AGENDA
DESIGN REVIEW COMMITTEE
September 28, 2023

**HISTORIC PRESERVATION BOARD
DESIGN REVIEW COMMITTEE
STAFF REPORT
September 28, 2023**

Project #	HPB23-163
Project Type	New Construction of a Single-Family House
Property Address; Historic Name	1115 Josephine Street N/A
Historic District; FMSF#	Lake Hunter Terrace Historic District; N/A
Owner/Applicant	Joseph and Patricia Magee
Zoning; Context District; Future Land Use; SPI	RA-3; Urban Neighborhood; Residential Medium; N/A
Existing Use	Residential
Adjacent Properties	Residential
Previous Approvals	N/A

The Olivia Lynn
Joey Magee
1119 Josephine St. Lakeland, FL
Elevations

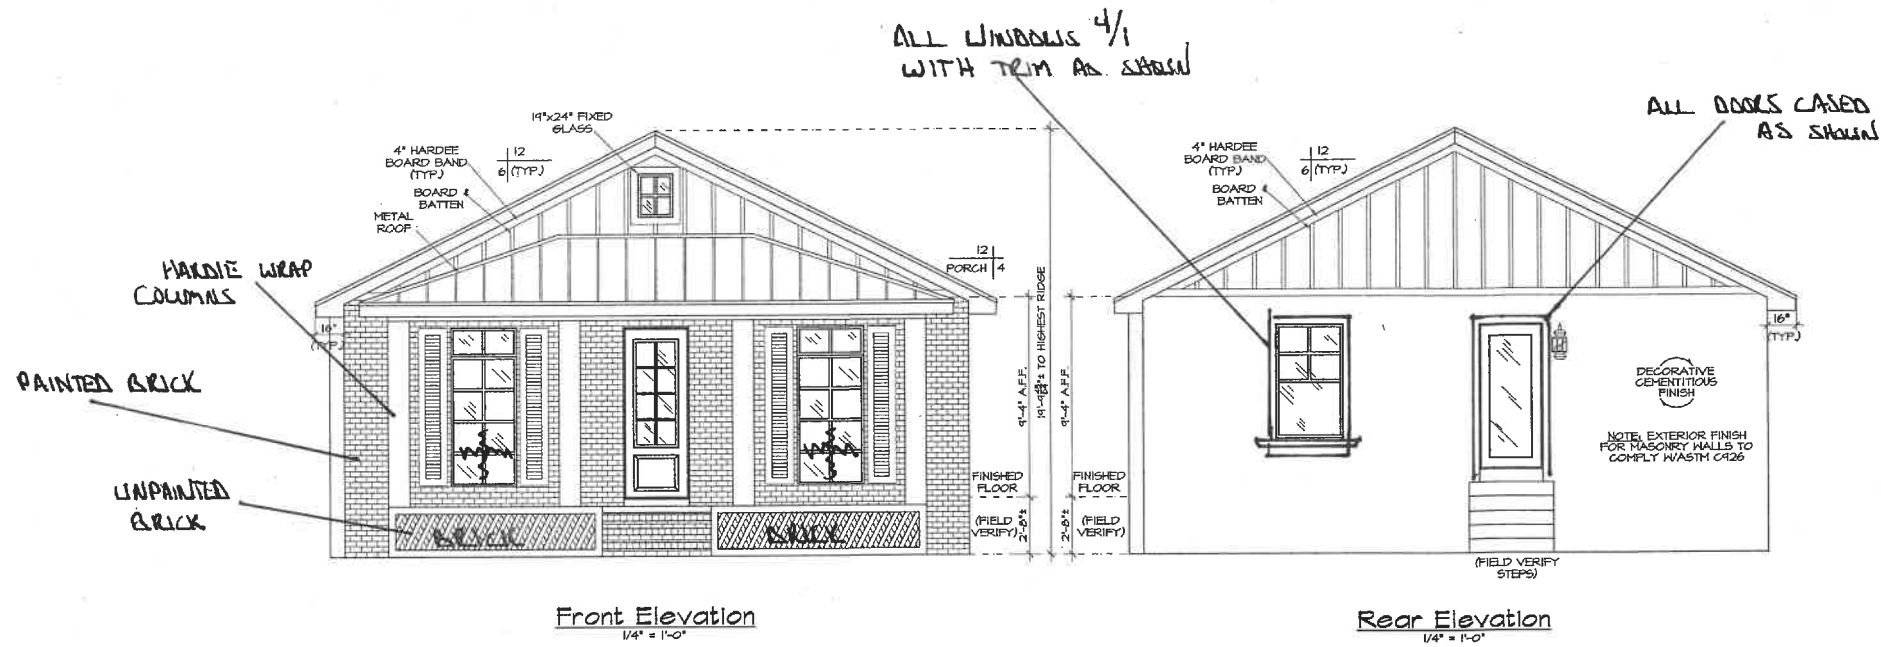
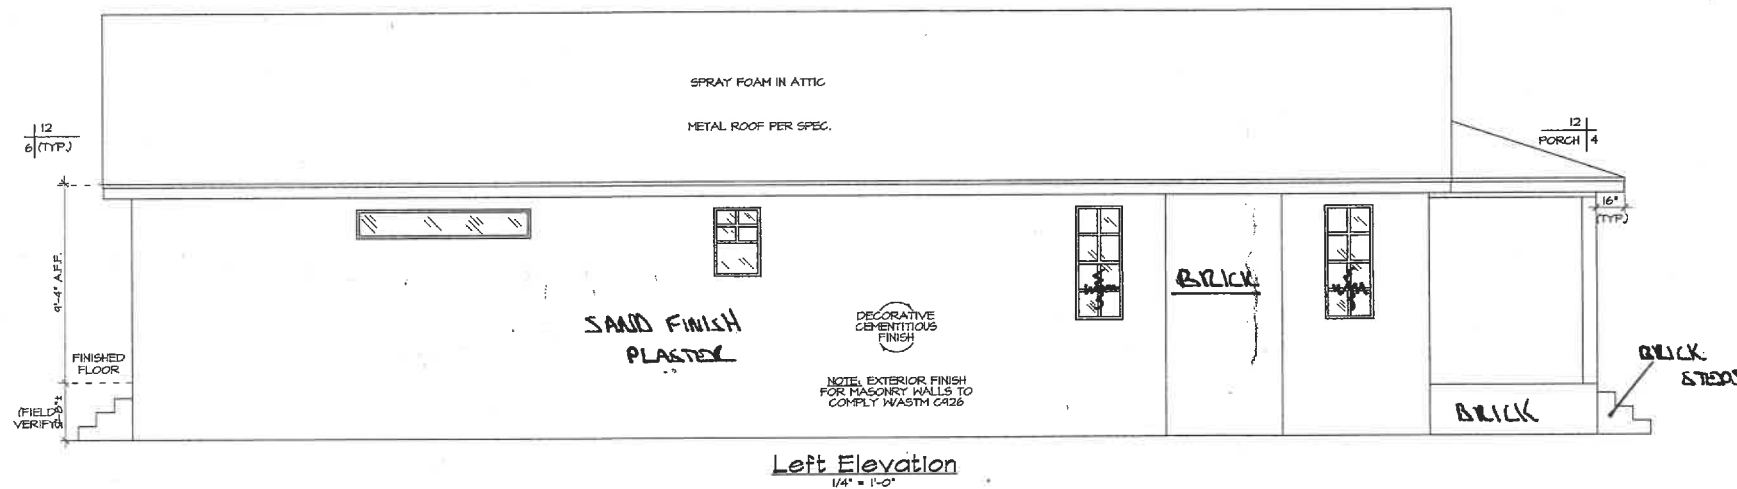
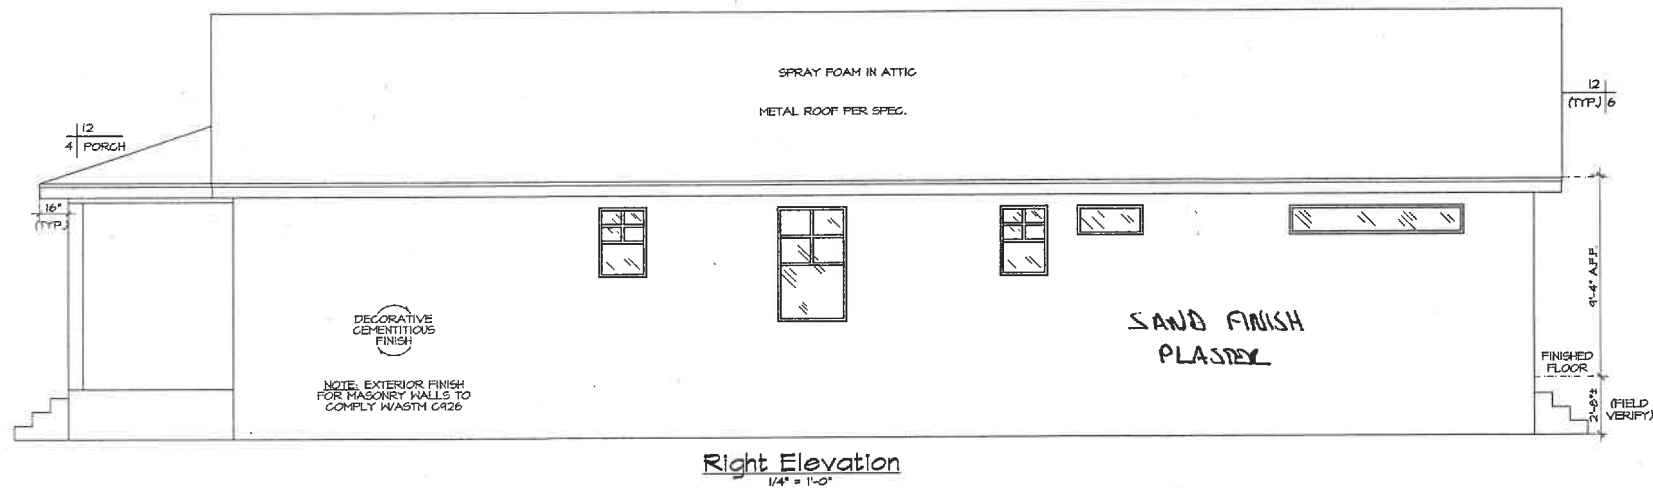
****The siding material and window lite configurations shown on the elevation drawings submitted by the Applicant will be revised to reflect the materials listed above.***

1. Use a straight eave return on the gabled roof instead of the “pork chop” eave return shown on the plans.
2. Windows shall comply with the following requirements:
 - a. Windows must be recessed to provide a shadow line and not installed flush to the exterior wall surface.
 - b. Muntins or “grids” must be mounted to the exterior glass, in addition to any grids between the glass.
 - c. Windows also must include historically appropriate trim, including header, sill, and apron.
3. The standing seam metal roof panels must have a flat appearance in between seams with no striations.
4. Submittal of an exterior paint palette.

NEW SPECULATION HOUSE FOR
WALLER CONSTRUCTION, INC.
 527 WEST PARK STREET
 LAKELAND, FLORIDA 33803

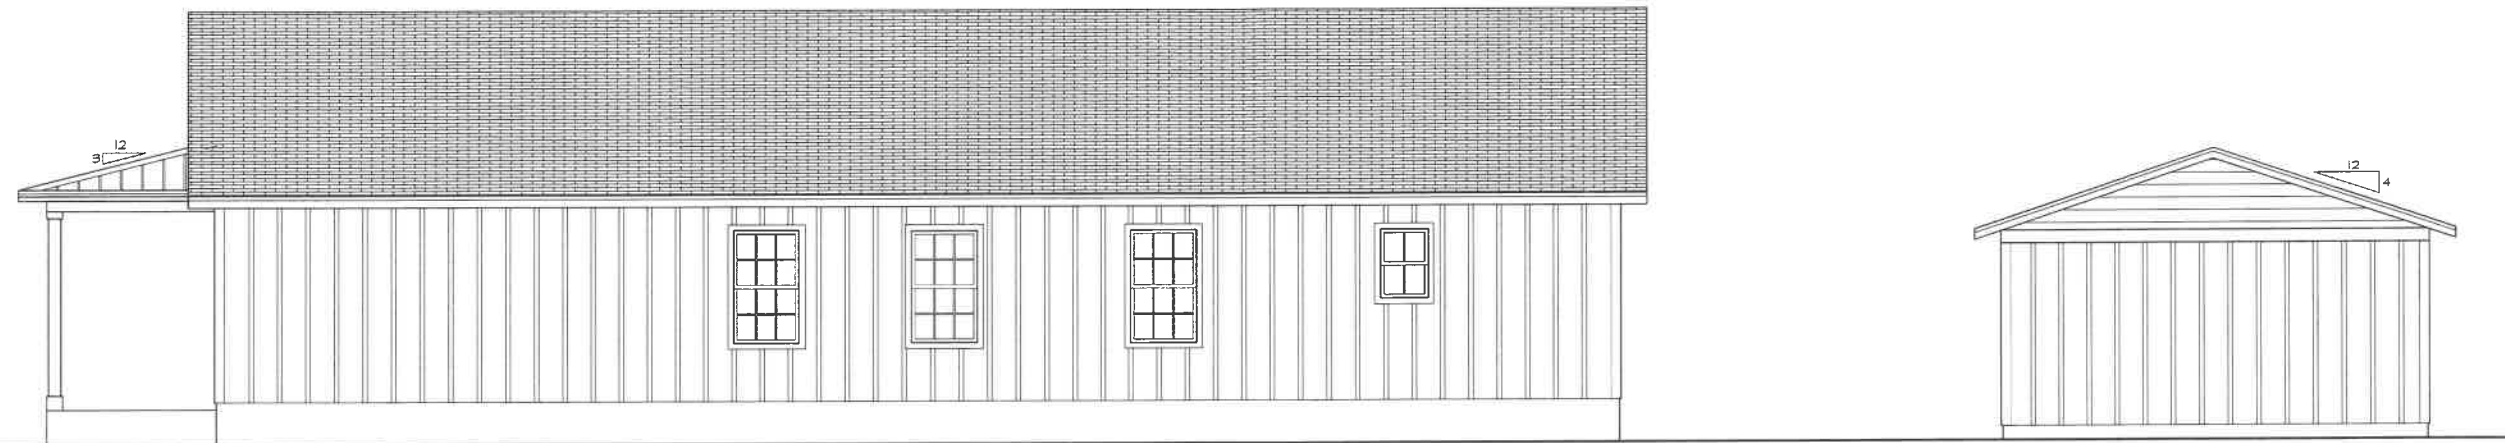
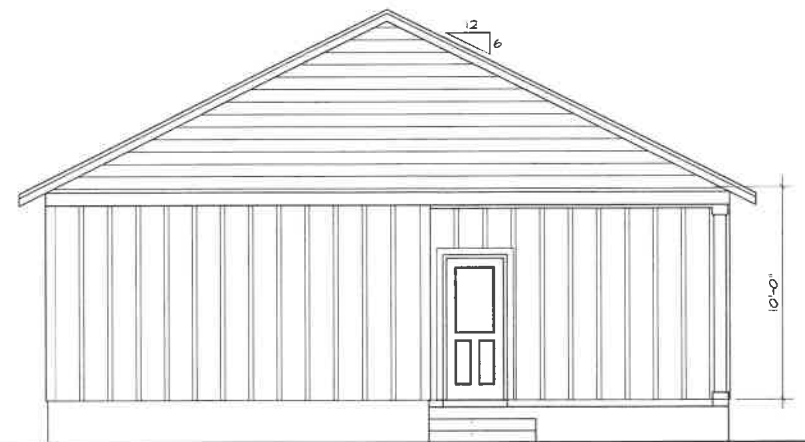
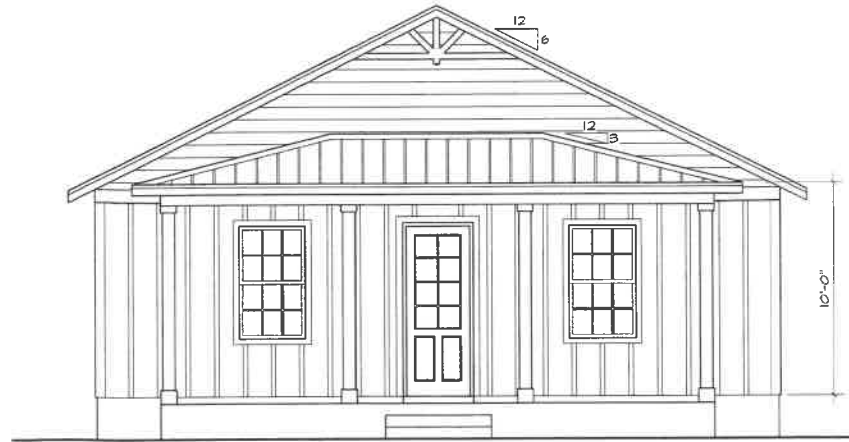
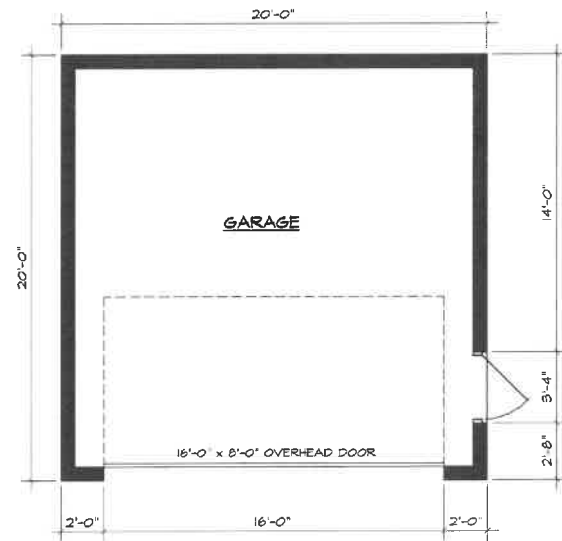
1. Use a front yard setback of 20 to 25 feet.
2. Windows shall comply with the following requirements:
 - a. Windows must be recessed to provide a shadow line and not installed flush to the exterior wall surface.
 - b. Windows also must include historically appropriate trim, including header, sill, and apron.
3. Submittal of an exterior paint palette.
